# City of Surrey PLANNING & DEVELOPMENT REPORT File: 7911-0071-00

Planning Report Date: April 23, 2012

## **PROPOSAL:**

to allow subdivision into thirteen (13) small suburban single family lots.

SKETCH 3

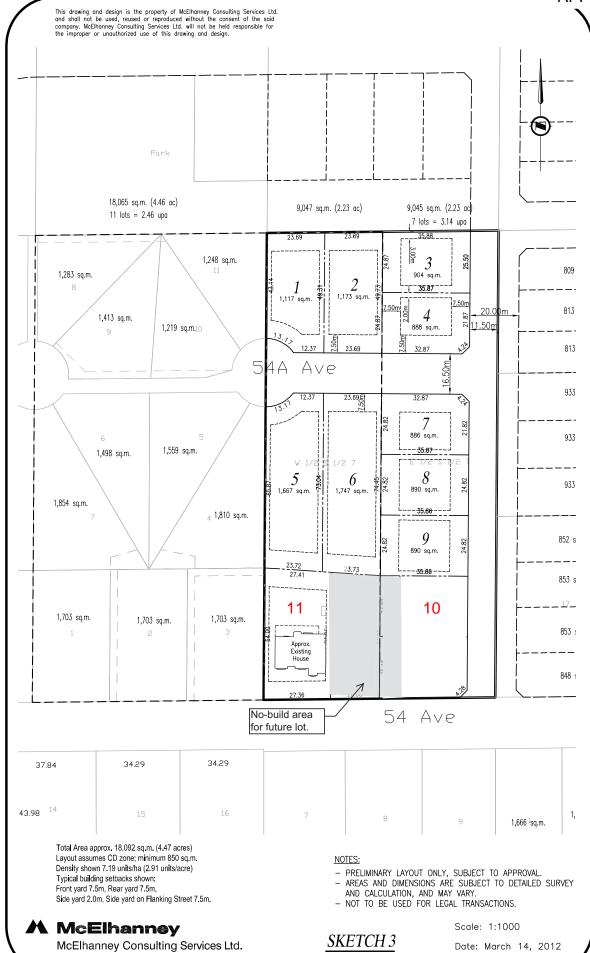
• However, the applicant recently did provide an alternative layout (Appendix III). The applicant reduced the number of lots proposed along 187 Street from 7 to 6, reducing the overall yield from 13 to 12 with 5% cash-in-lieu for parkland (rather than 15% which is consistent with the RH-G Zone). As the alternative layout still proposes a 20-metre (66 ft.) wide lot fronting 54 Avenue and the proposed subdivision requires a CD Zone based on RH-G, this layout is not supported by staff.
